## **CLEAR CREEK SUBDIVISION**

Engineering Comments: FINAL PLAT COMMENTS (should be addressed prior to submitting the FINAL PLAT for review and/or signature by the City Engineer):

APPLICATION NUMBER 1 DATE April 4, 2019

# DETAIL SITE PLAN

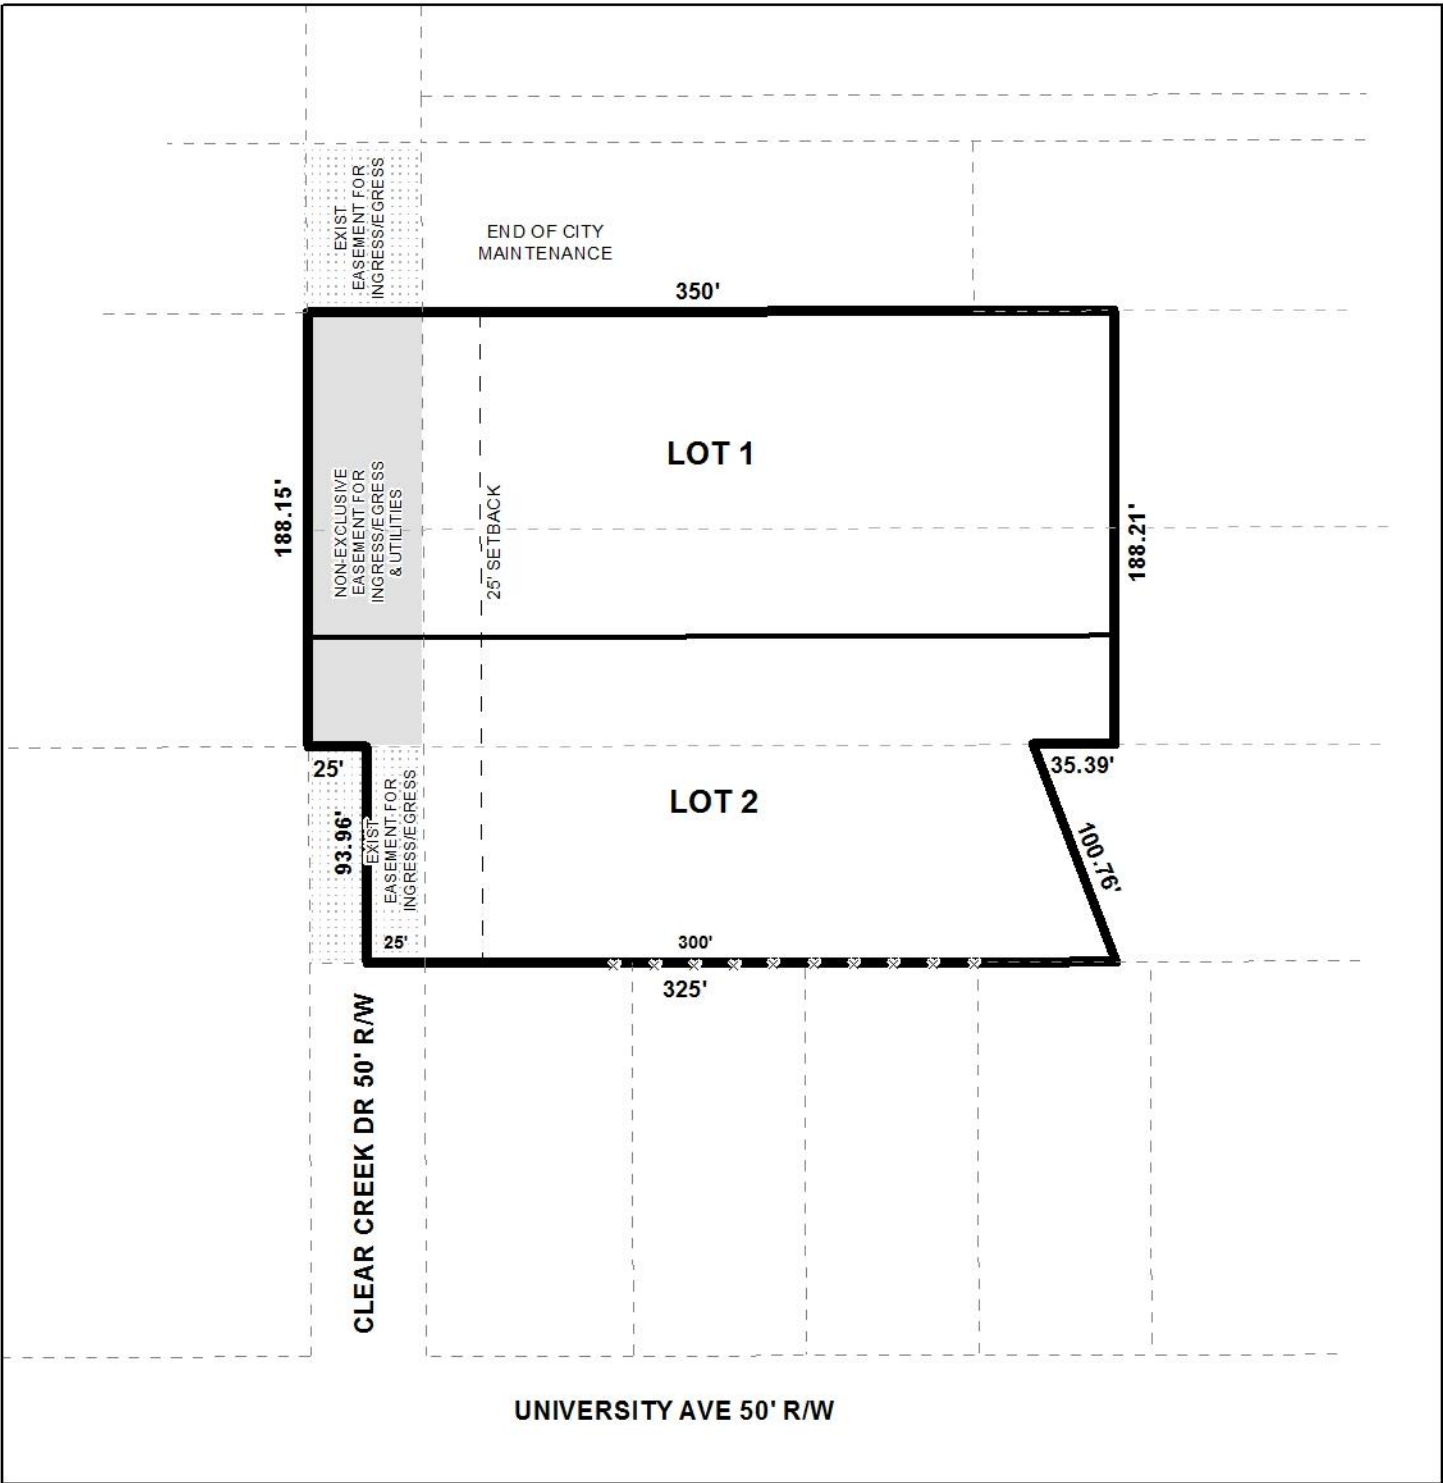
The applicant's narrative, as well as the proposed site plan, indicate existing easements for ingress/ egress to the North of the subject site, as well as in front of a portion of the proposed Lot 2. However, there was no documentation provided with the application supporting this information. Copies of both existing easements should be submitted to the Planning and Zoning

Department for staff's review. The applicant also proposes to dedicate 50' from Lot 1 and a portion of 50' and 25' from Lot 2 to create a continuous non-exclusive easement.

It should also be pointed out; the newly proposed plat appears to exclude a portion of the proposed Lot 2 located in the southeast corner of the lot. The plat that was submitted with the 2018 application depicted the rear portion of all the lots as straight lines as opposed to the indentation proposed on Lot 2. The inclusion of all of the property identified within the parcels must be depicted on the plat, and be included in the subdivision process.

*As previously referenced, the 2018 application indicated that the eastern property line had a due north/south lot line. In reviewing the applicant's documents, it appears, based on a "less and except" parcel, that the eastern portion of the property line adjoining the proposed Lot 2, should be vertical. This will correspond to the existing parcel line, thus the final plat should be revised to correspond to the existing "vertical" parcel line.*

- 8) the plat should be revised to include the remaining portion of the proposed Lot 2 to reflect a vertical parcel line as oppose to the irregular line depicted on the current preliminary plat; and*
- 9) full compliance with all municipal codes and ordinances.*
